DRAFT

B 3.6 CONTAINMENT SYSTEMS

B 3.6.1 Containment (Ice Condenser)

Figure 3.7.¹⁵~~17~~-1 (page 1 of 1)
Fuel Assembly Burnup Limits in Region 2

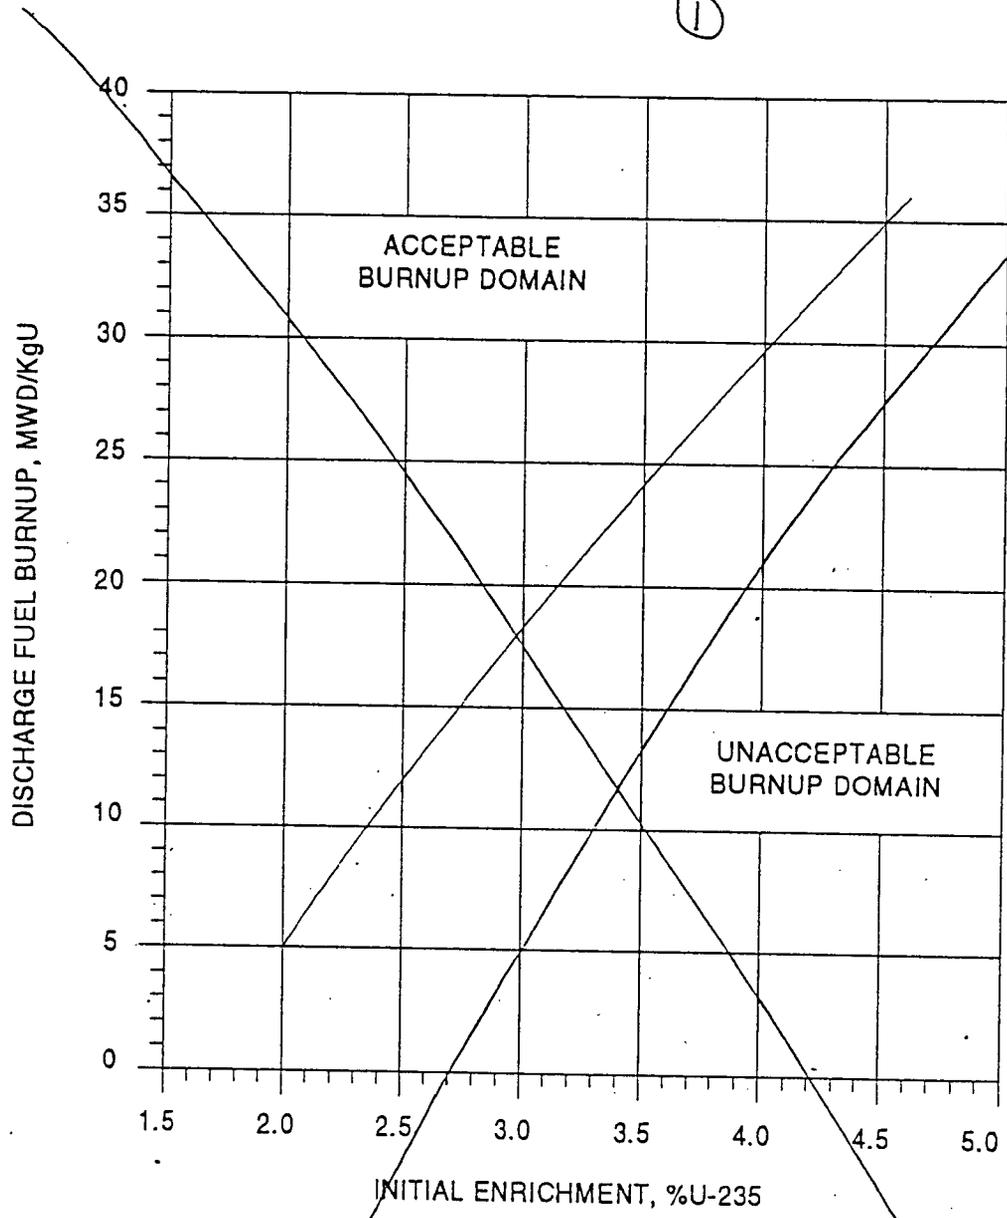
①

Not to be used for Operation.
For illustration purposes only.

Figure 4.1-1 (page 1 of 1)
Site and Exclusion Area Boundaries

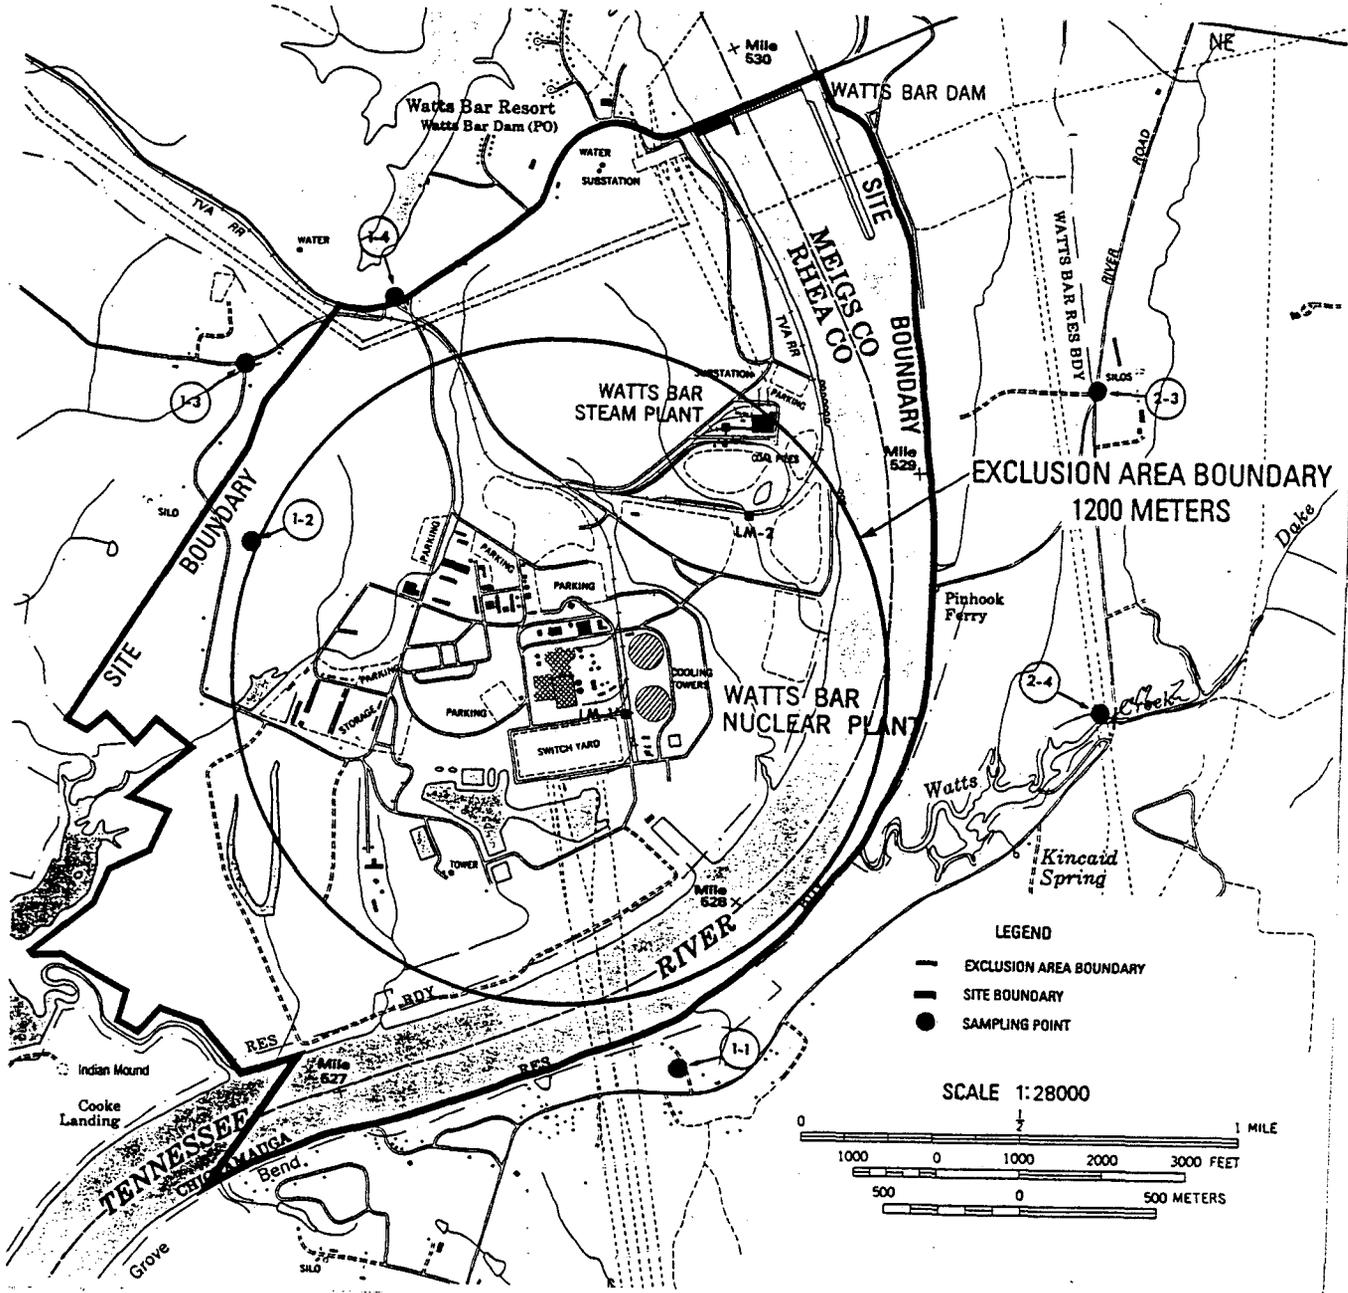
9 → The site and exclusion boundaries shall be as ~~described or as~~ shown in Figure 4.1-10. 3

INSERT

Figure 4.1-2 (page 1 of 1)
Low Population Zone

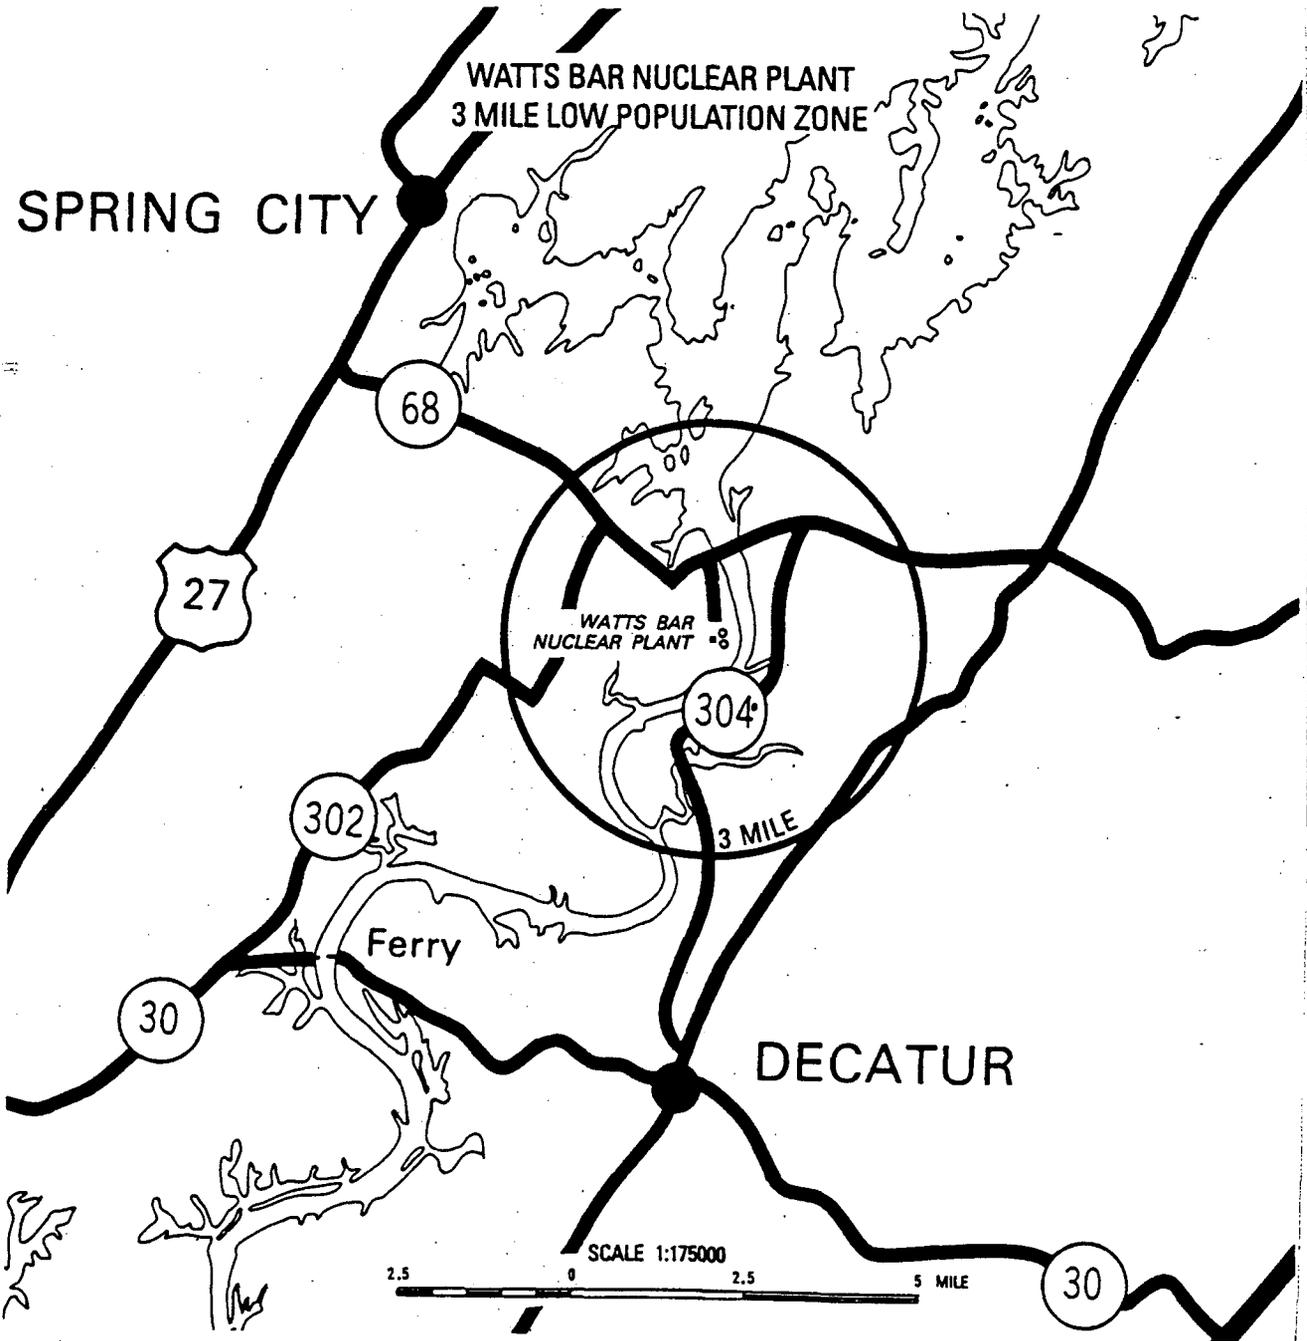
9 → The LPZ shall be as ~~described or as~~ shown in Figure 4.1-20x (within the 3-mile circle). 3 5

INSERT
